Pre-Application Summary Report (list of questions)
(16 August 2013)

Macklin Street 23 pre-app

Request for Pre-application Advice

172
23 Macklin Street
Design and Access Statement
Appendix
November 2013

Figure 1. Roof Plan
23 Macklin Street

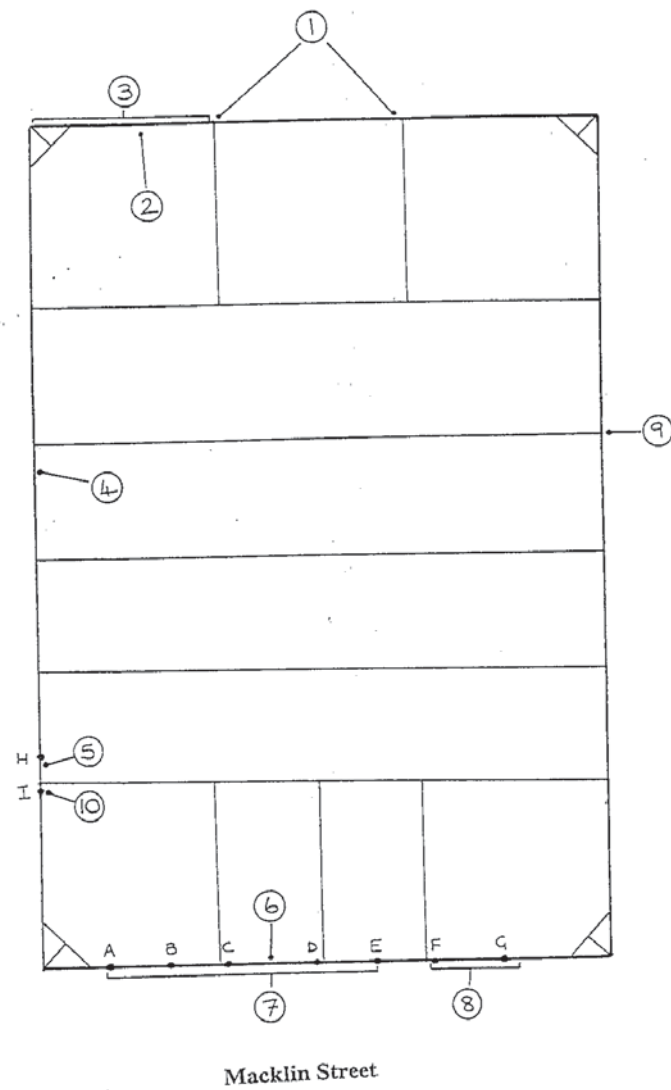
The locations of our observations are identified as points 1-10 in figure 1. These are detailed as follows:

1. Tie beam bearings embedded into the brickwork. Bearing sound as far as accessible.
2. Rafter badly fractured.
3. Considerable water ingress, but no significant decay.
4. Considerable water ingress. One rafter foot slightly decayed by a white resupinate fungus. Back of wall plate decayed by a white rot. Damage superficial. Currently dry.
5. Rafter plate fractured.
6. Large plant root/stem (approximately 20mm diameter) penetrating masonry.
7. Undersurface and back of wall plate decayed.
8. Wall plate appears compressed.
9. Small patch of wet rot decay in beam end. Bearing not decayed.
10. Wall plate decayed at back adjacent to tie beam.

Sites of drillings are located as points A to I in figure 1. All drillings were made into the wall plate. At each of the sites A to G, three drillings were made horizontally into the vertical face of the wall plate. The first (1) at a height of 30mm from the top of the wall, the second (2) at 70mm, and the third (3) at 150mm. This enables us to begin to estimate the extent of the decay at the back of the plate. Our findings are as follows:

There has been considerable water ingress at roof level, but comparatively little decay. We would attribute this to the high quality and natural durability of the timbers. Where timber is in contact with damp masonry, particularly on more than one face, then the likelihood of decay is high. The most significant decay by far is restricted to the wall plate on the Macklin Street elevation where large sections are decayed at the back.

It may be necessary to replace the wall plate on this elevation. We would suggest that good quality Douglas Fir be used as replacement, and that this should be isolated from the wet masonry with a damp proof membrane. Alternatively, repairs could be made using reclaimed timbers of similar age and quality.

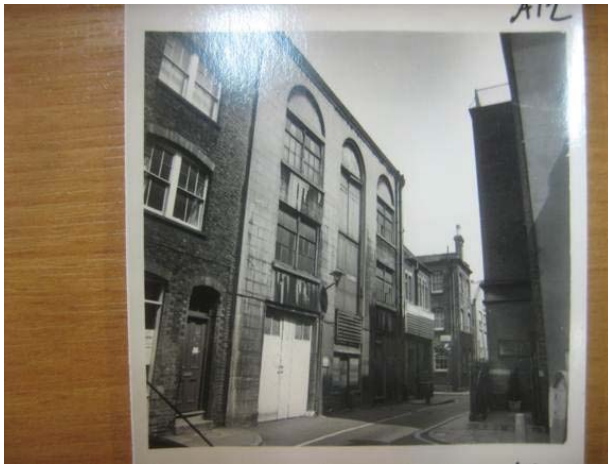
19 New south façade windows, 20 New garage door, 21 New staff door, 22 New main entrance door, 23 Removal of façade paint and render, 24 Timber shutters to be removed from façade windows Historic pictures – a photograph from 1976 and a watercolour from the mid 1980s – show a similar arrangement to the existing, albeit with a taller central door and slightly differently arranged windows. At that time, the finish appears to have been render, scored to resemble ashlar. The current façade seems to be a modernised version of the façade present in 1976. If it can be shown that the 1976 arrangement is not of historic interest, proposed changes will be judged on the merits of the submission. (Two pictures follow)

25 Potential chimney alteration The chimneys are not an important part of the composition – within its context, the building will not be noticeably unbalanced by their not matching. Alterations to the eastern chimney would therefore be unwelcome.
